A G E N D A

Architectural Review Board

June 26, 2018

753 Thorn Place

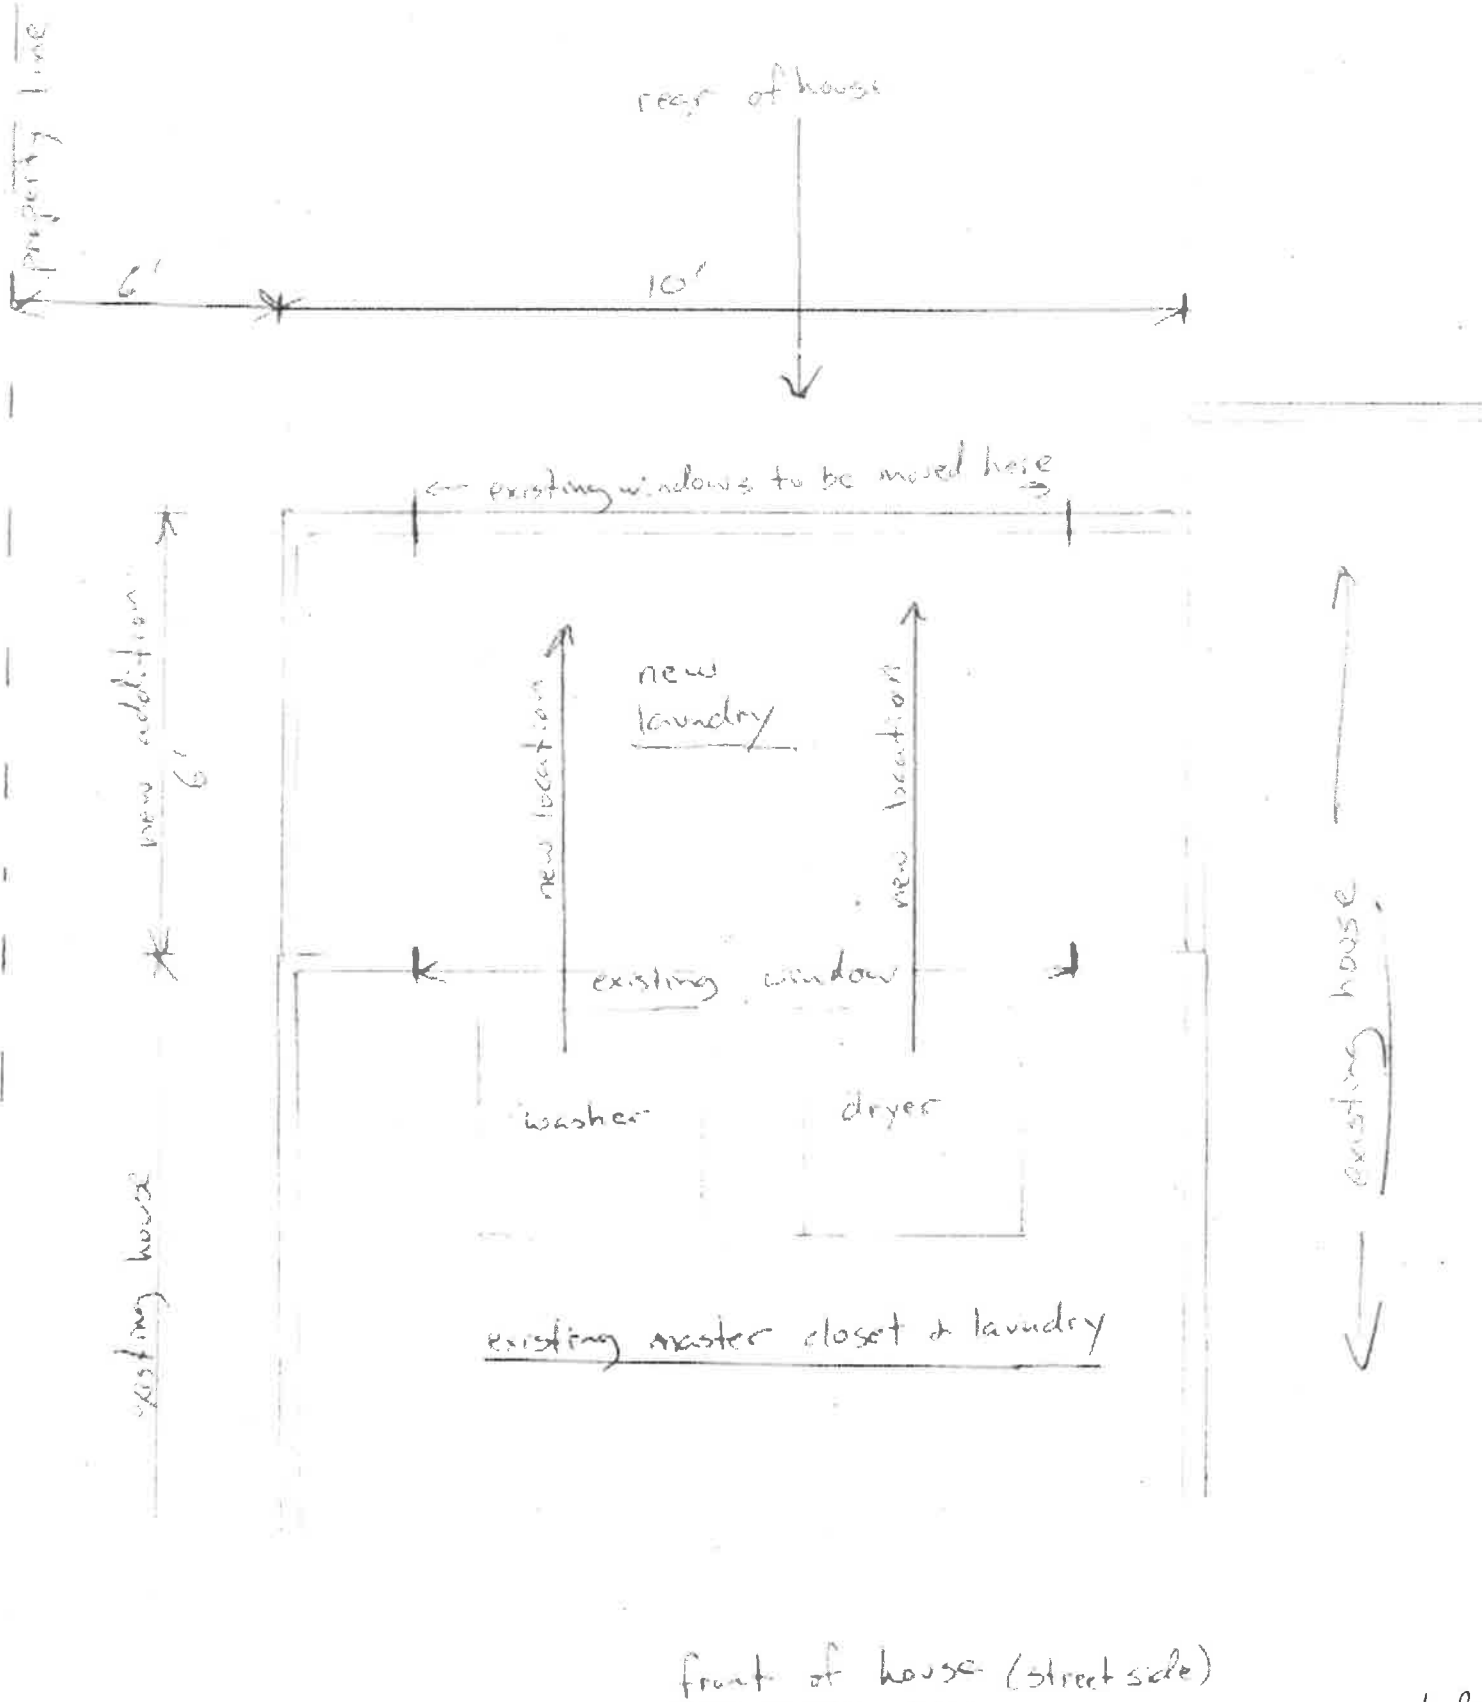
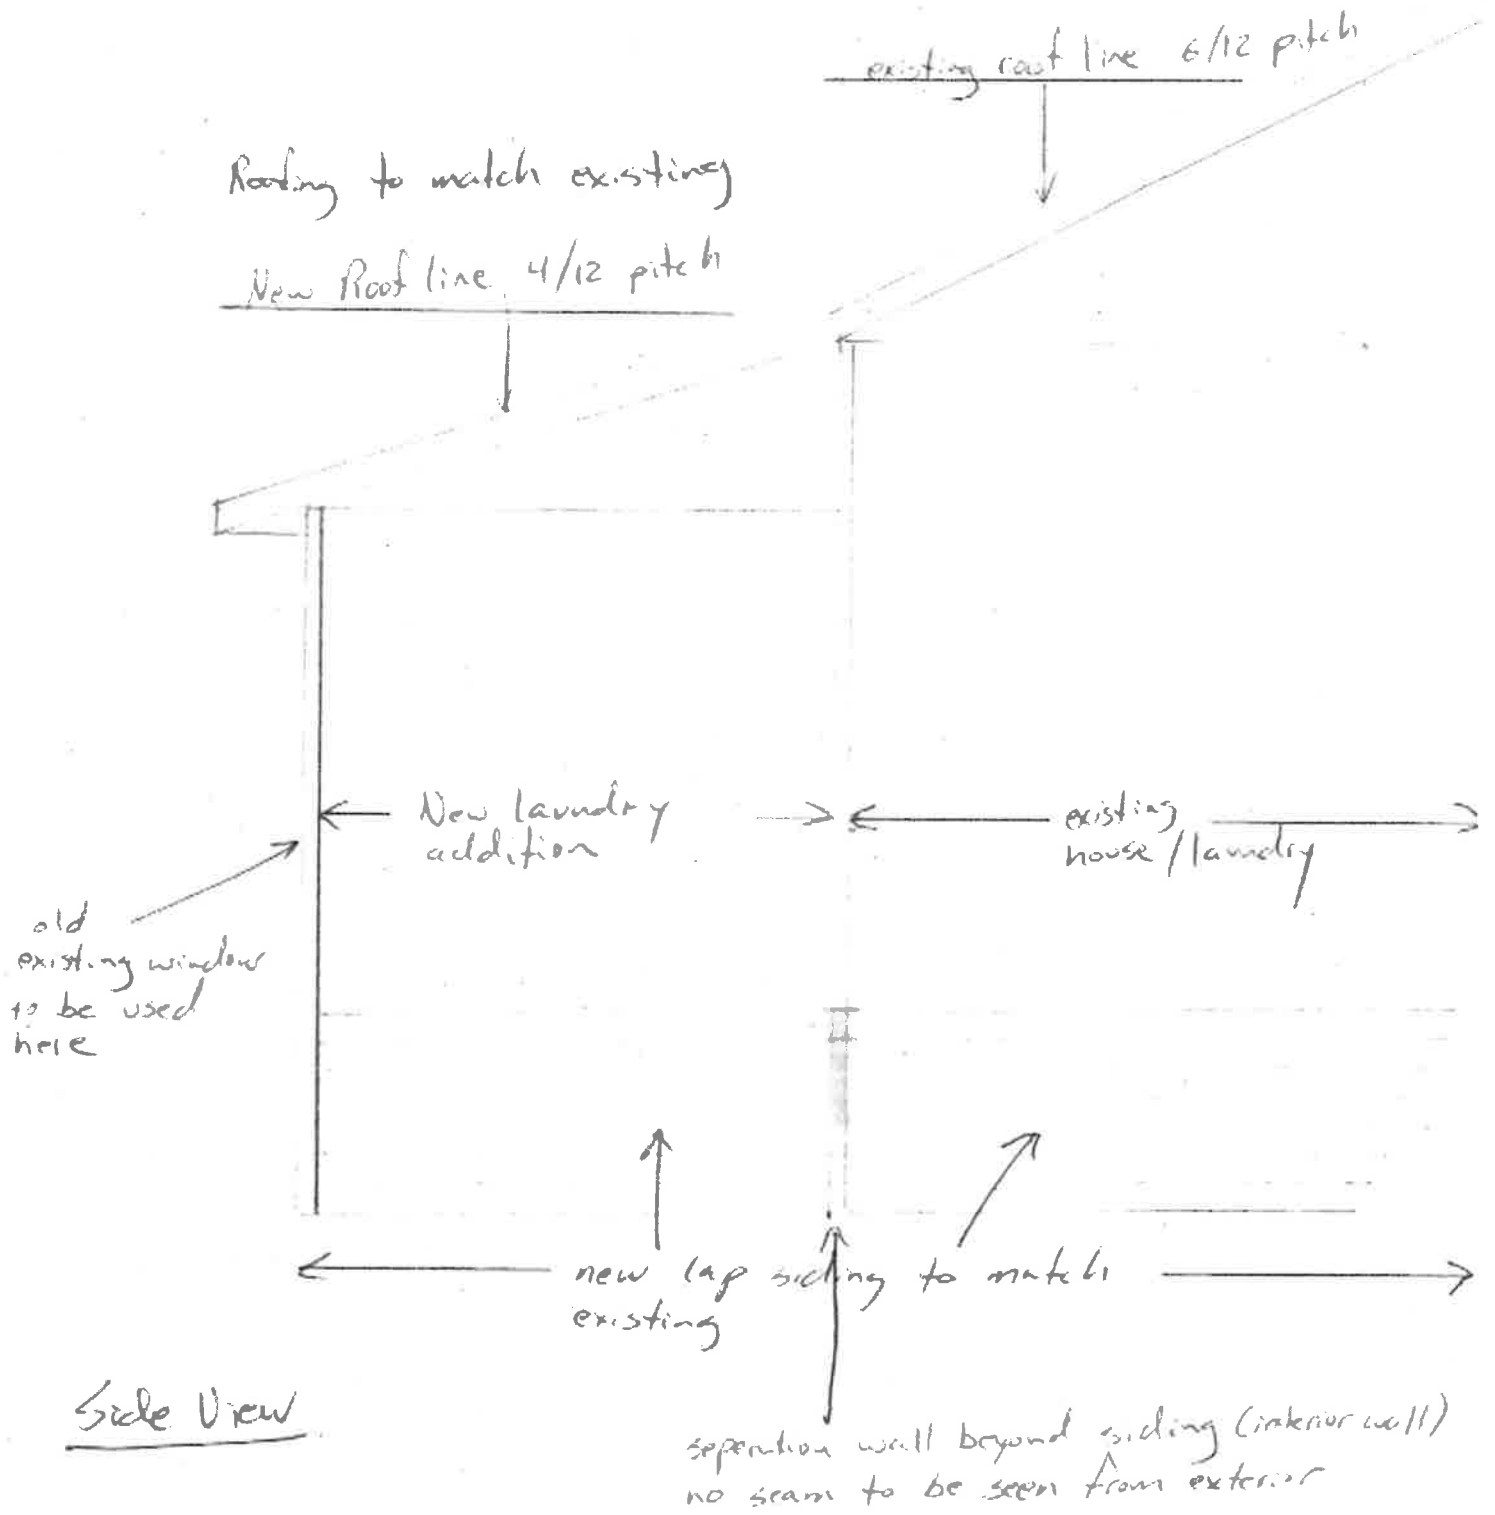
- No objection.

767 Felder Avenue

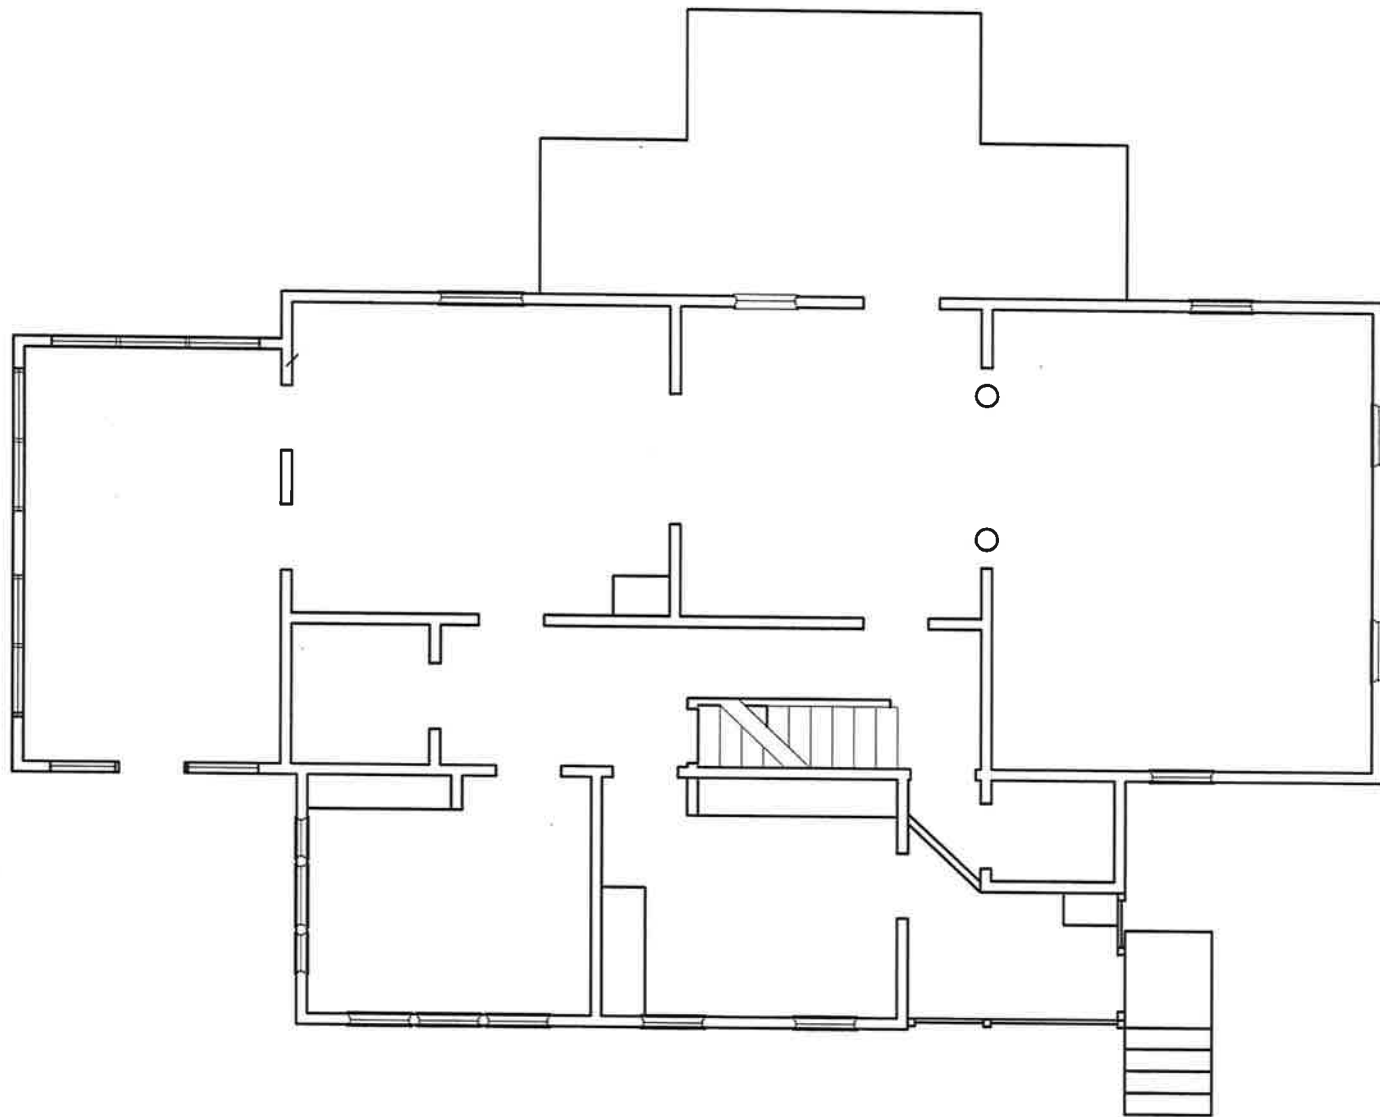
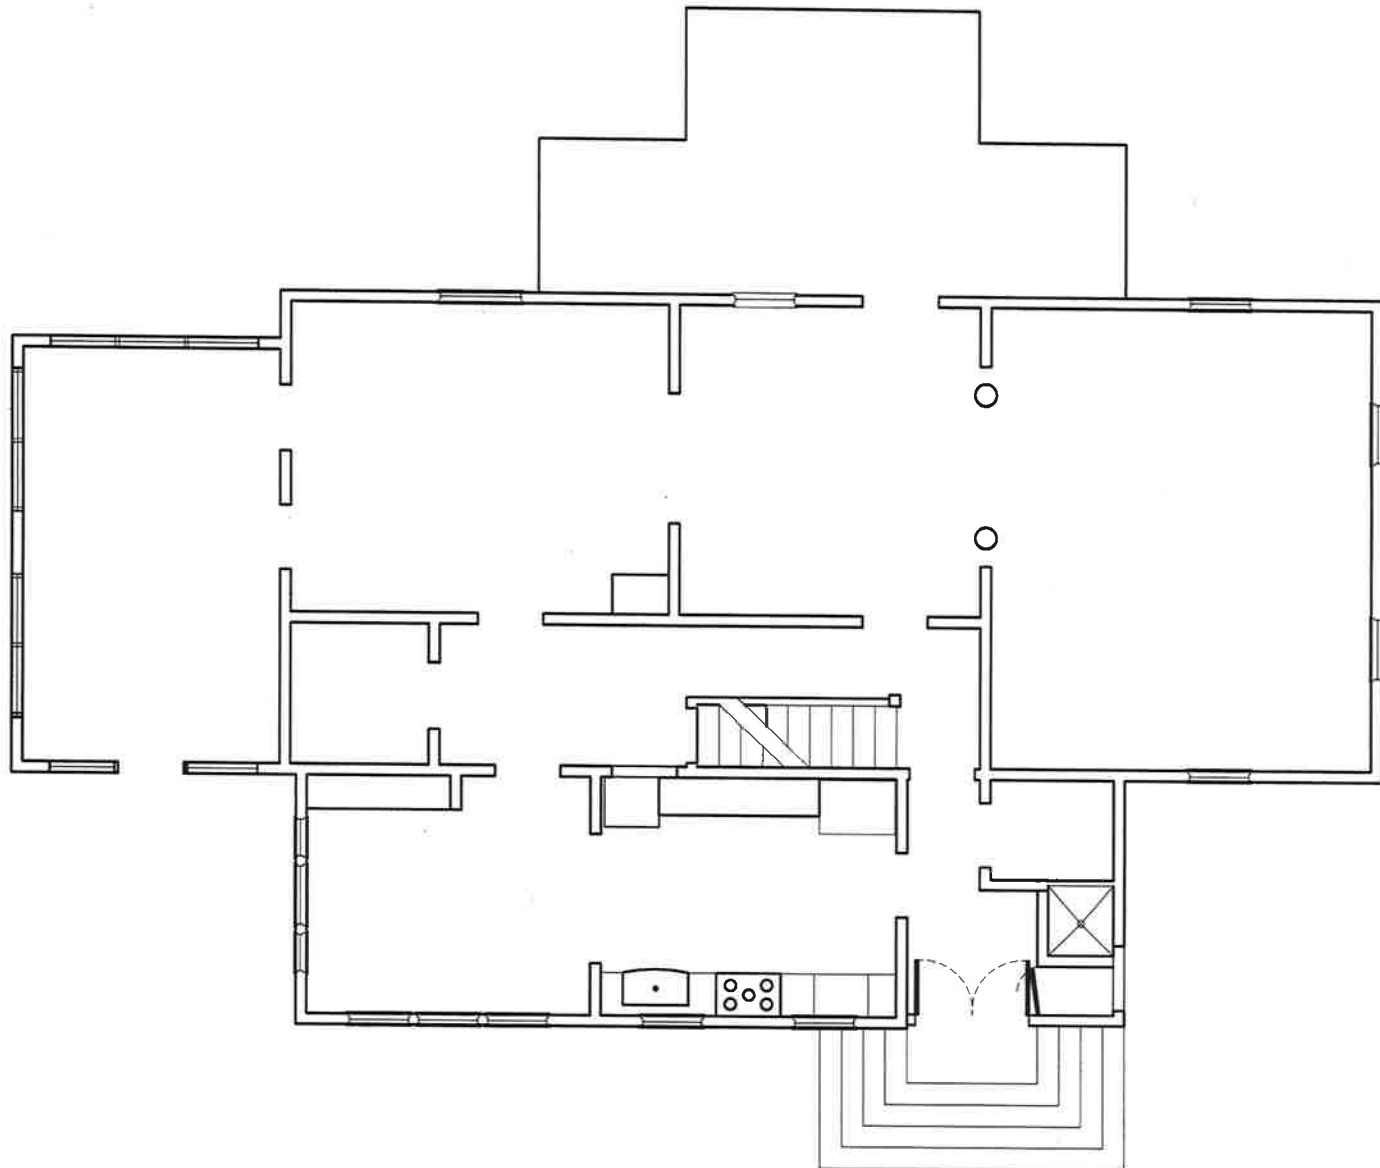
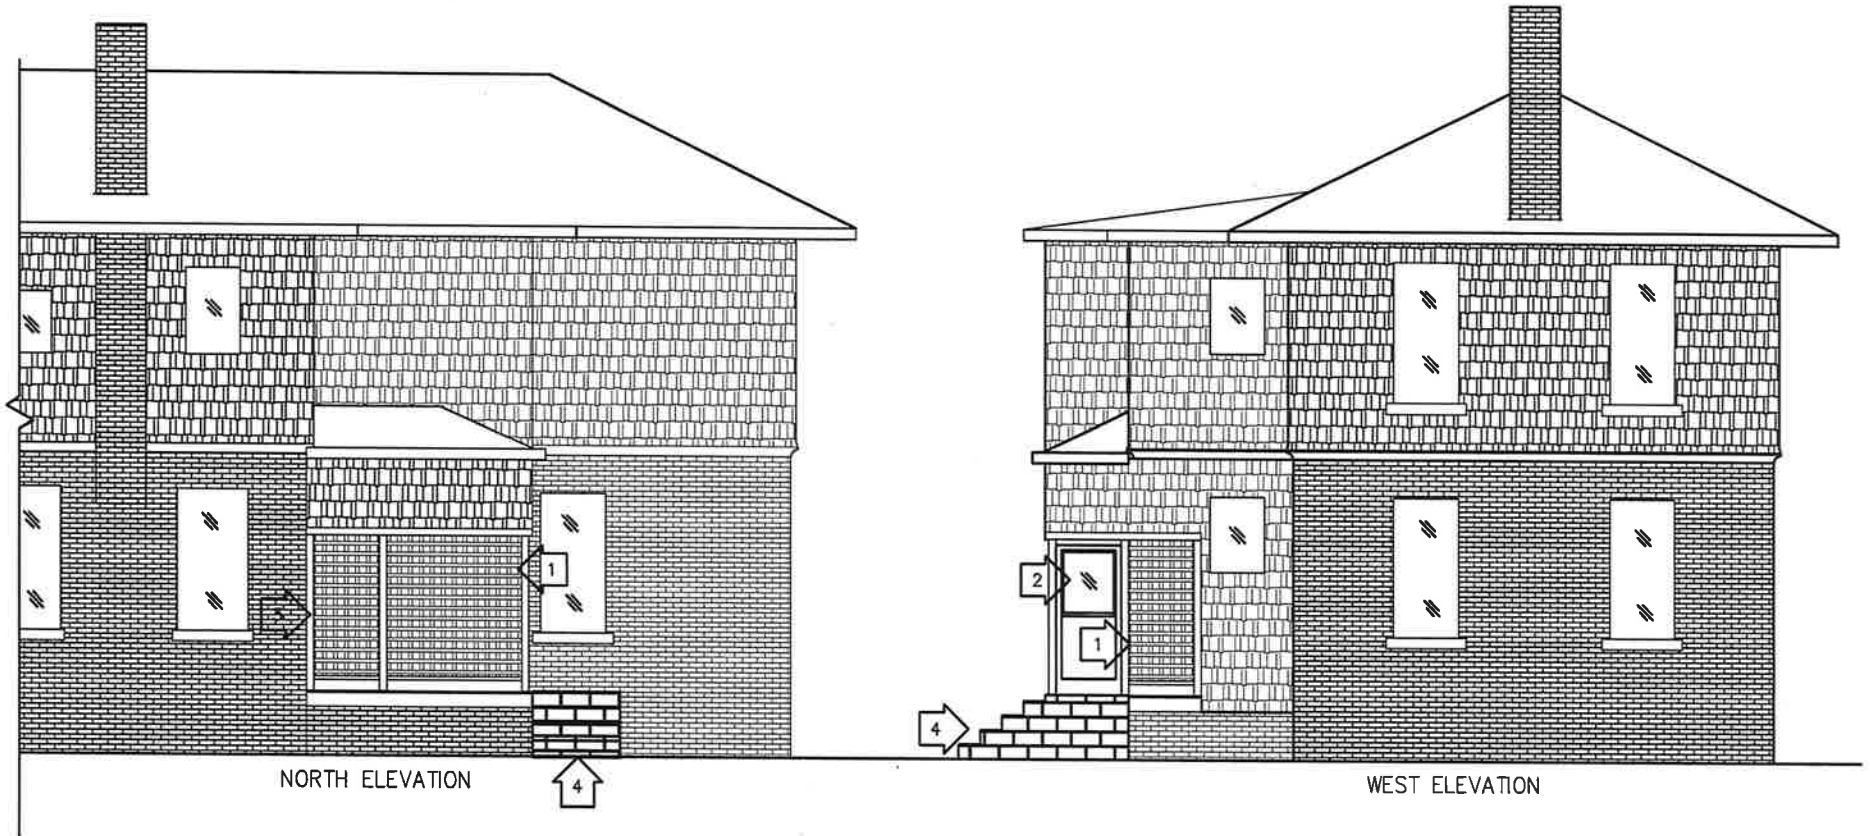
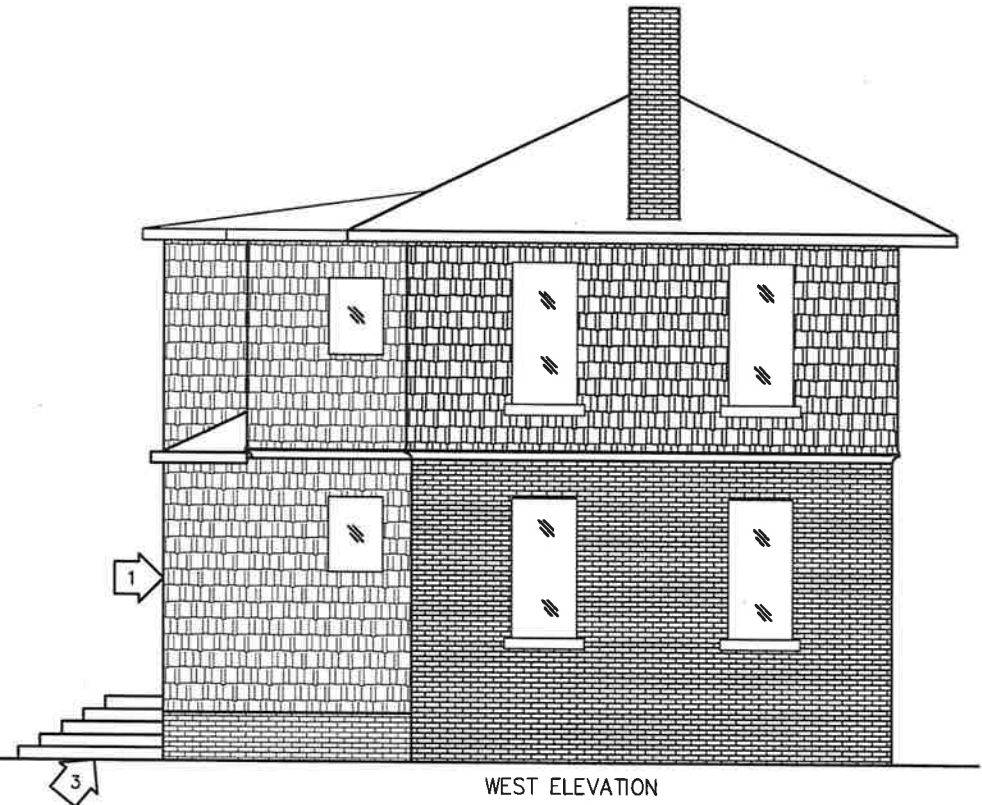
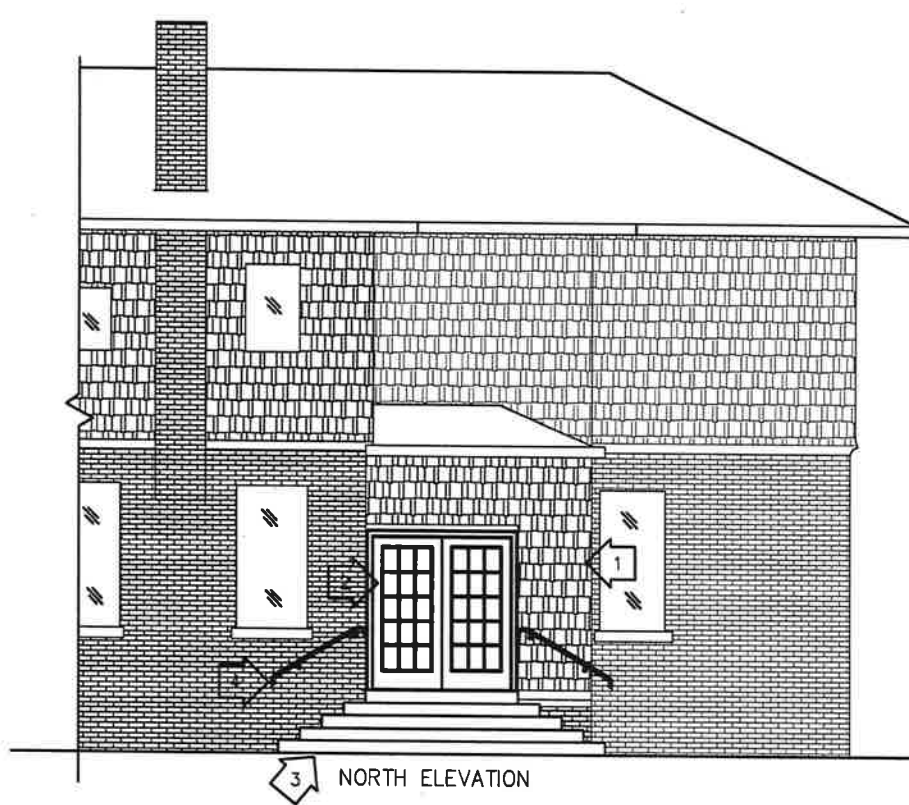
- No objection as long as a wood rear door is specified and if a new door is required in place of the salvage door, any lite configuration needs to have a simulated divided lite (grid on the glass).
